M E M O R A N D U M

TO: KIM HOLT – SYNEY NORTH PLANNING PANEL SECRETARIAT
FROM: KIM ROTHE – SENIOR ASSESSMENT OFFICER
DATE: 4 June 2018
RE: **RE: 2018SNH010 – 149 West Street, Section 4.55 Supplementary Report
Notification of Concurrence of Conditions**

Re: Cammeraygal High School - Response to Submissions

Figure 1 Example monitoring results (see Report 17071 Appendix A)

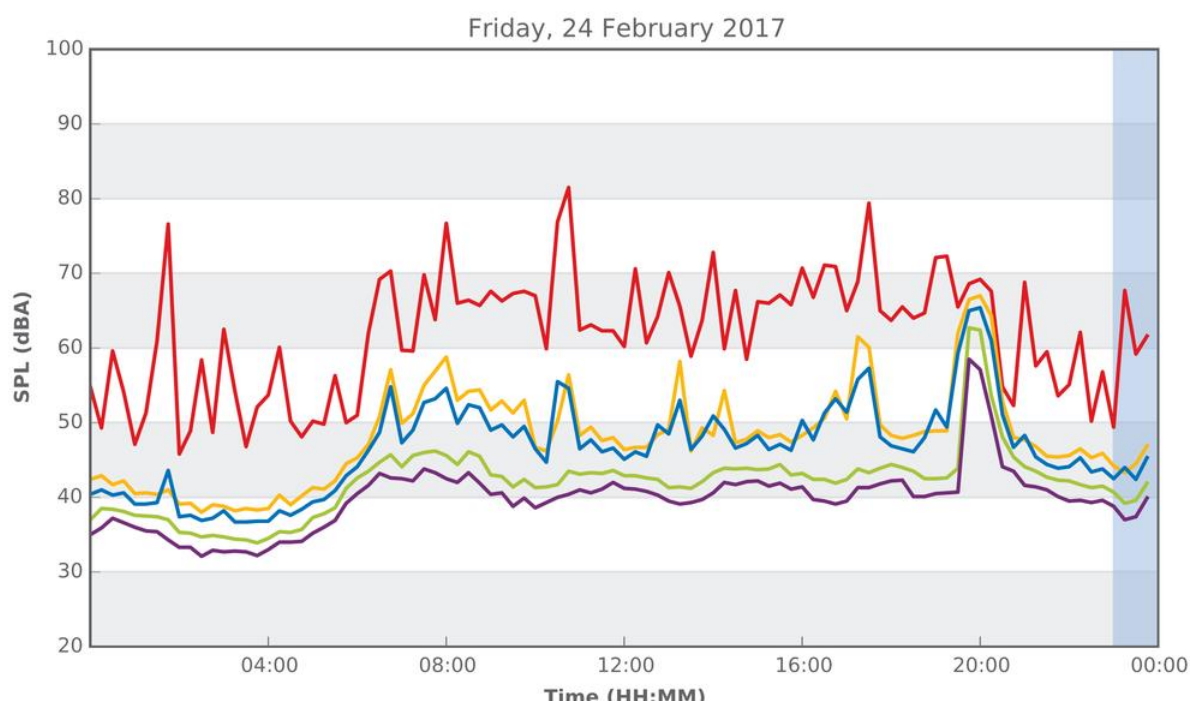
To help understand what this means, consider the following noise logger chart recorded at the site near the rear boundary. The chart is taken from the appendix to our DA report. The most important line to consider is the blue line which shows the $L_{Aeq,15min}$ minutes throughout the day. During the evening period from 6.00pm to 10.00pm on the example day and other days, the L_{Aeq} is typically 45 to 47dBA. (At this location there were some increases around 8.00pm to 60dBA, but these are excluded from our analysis.) The level recorded over 1 week of evenings was 52dBA as shown in Table 1.

The predicted level from the hall is similar to the existing environmental noise level in the area. So, while noise from the hall may be audible in the rooms facing the school, so will all the existing environmental noises that make up the background be audible – transportation, insects, wind in the trees etcetera. The intention of the noise policy is to reduce the new noise from the school to a level where it is not intrusive when compared to the existing noise environment.
